City Works (Open Space)

The waste management plan for 4-6 Derby Street, Collingwood authored by Leigh Design and dated 21/9/23 is not satisfactory from a City Works Branch's perspective.

SLR Consulting Pty Ltd (SLR) has been retained by the City of Yarra to provide a review of the acoustic assessment report for the planning application at 4-6 Derby Street, Collingwood.

PREPARED FOR: Jessica Sutherland, Statutory Planning Branch, Yarra City Council
DATE: 19 January 2024
FILE: 2023-072

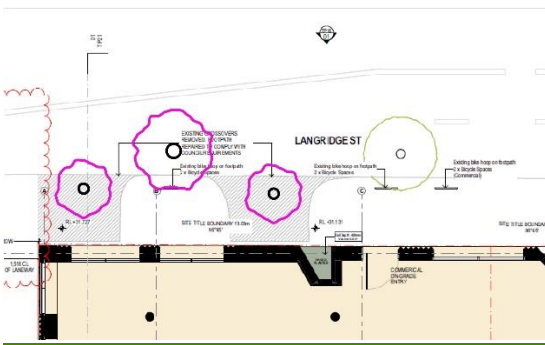
Ensure planter boxes are large enough to sustain plant growth to achieve the design vision. Example will climber sustain cover over 4 levels and close to 15m in height. Consider increased planting options around site boundary to mitigate the large swathes of blank walls that require further articulation.

Figure 2 Little Oxford St Street Wall

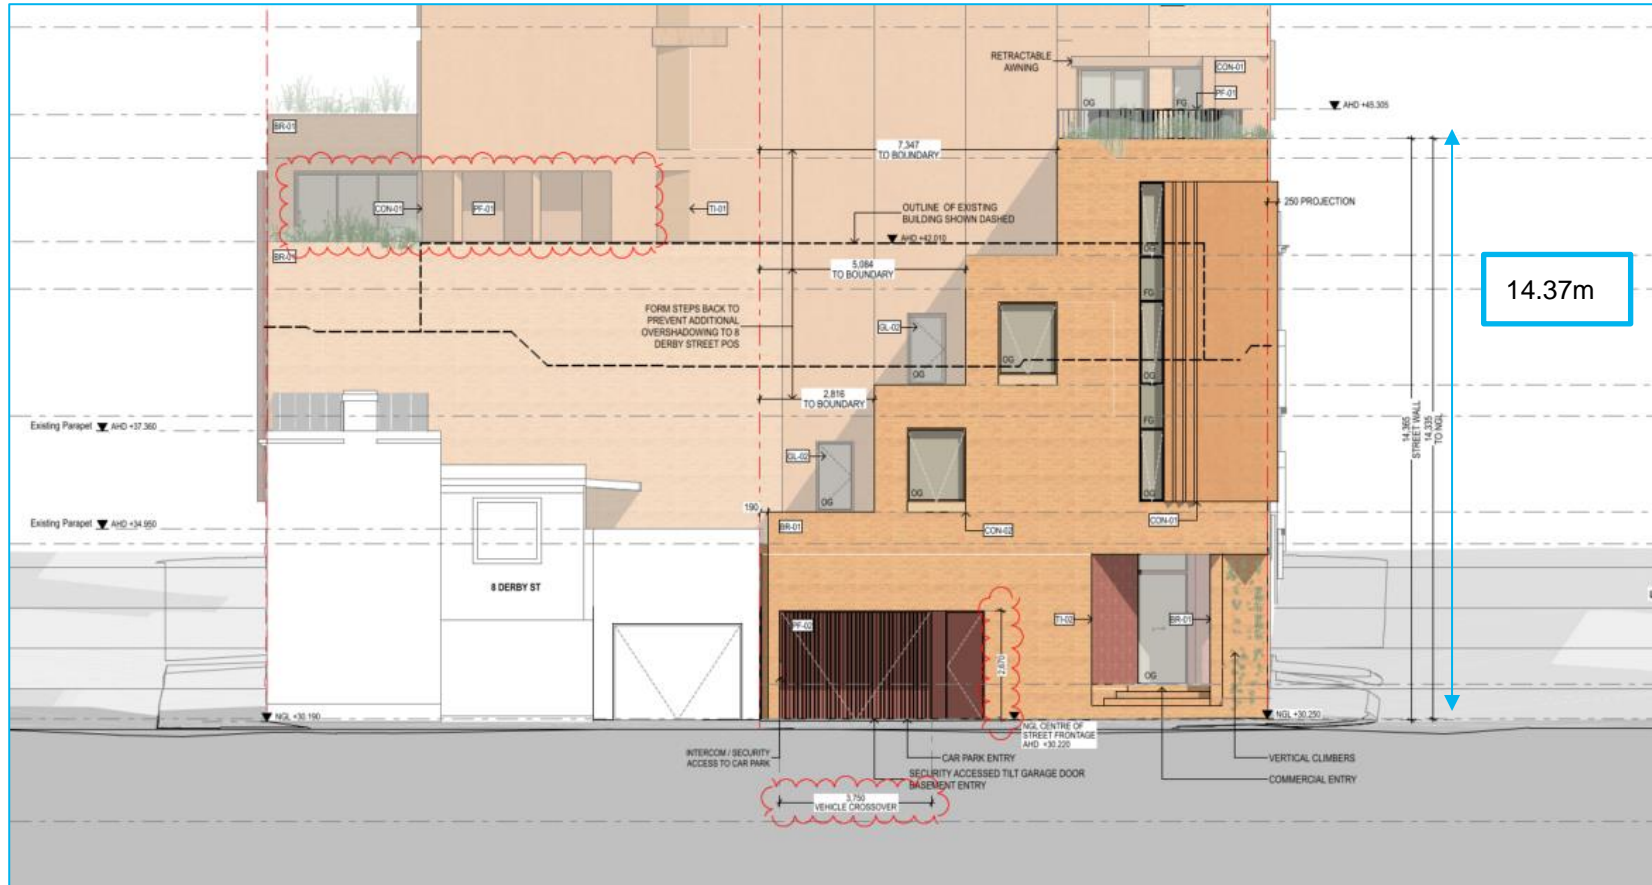
The street wall height varies on Little Oxford Street as shown in Figure 2. The tallest part of the street wall is 14.37m complying with the interim DDO however exceeding the proposed DDO by 3.37m.

It is considered that this variation should not be accepted given it does not meet the mandatory variation requirements. It is recommended that the street wall be lowered to meet the proposed requirement.
